# SPARC® Enterprise M8000/M9000 Servers Product Notes

For XCP version 1060

# SPARC Enterprise M8000/M9000 Servers Product Notes

**FIGURE1-18** SPARC Enterprise M8000 Server + Power Cabinet Bottom View

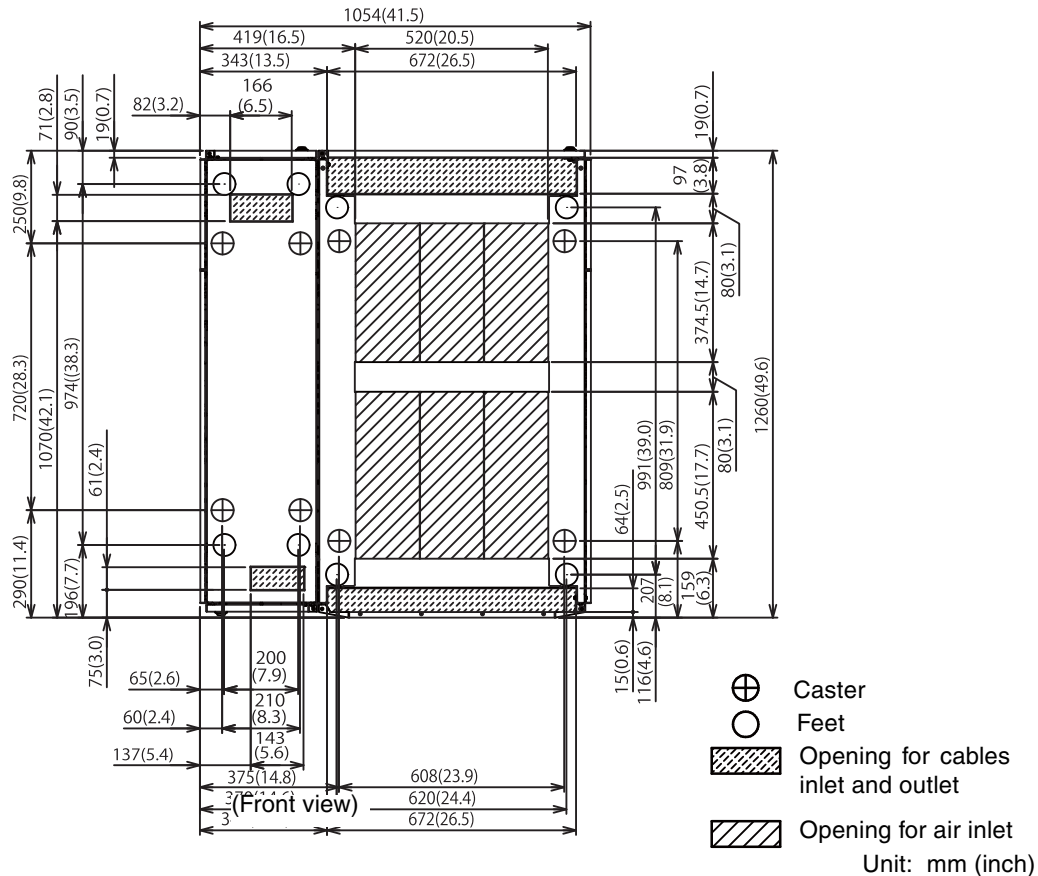
This is to correct the description in Section 1.2.2.2, "Bottom View of the Components", FIGURE 1-18 SPARC Enterprise M8000 Server + Power Cabinet Bottom View and FIGURE 1-20 SPARC Enterprise M9000 Server (Base Cabinet) + Power Cabinet Bottom View. The correct figures are as follows:
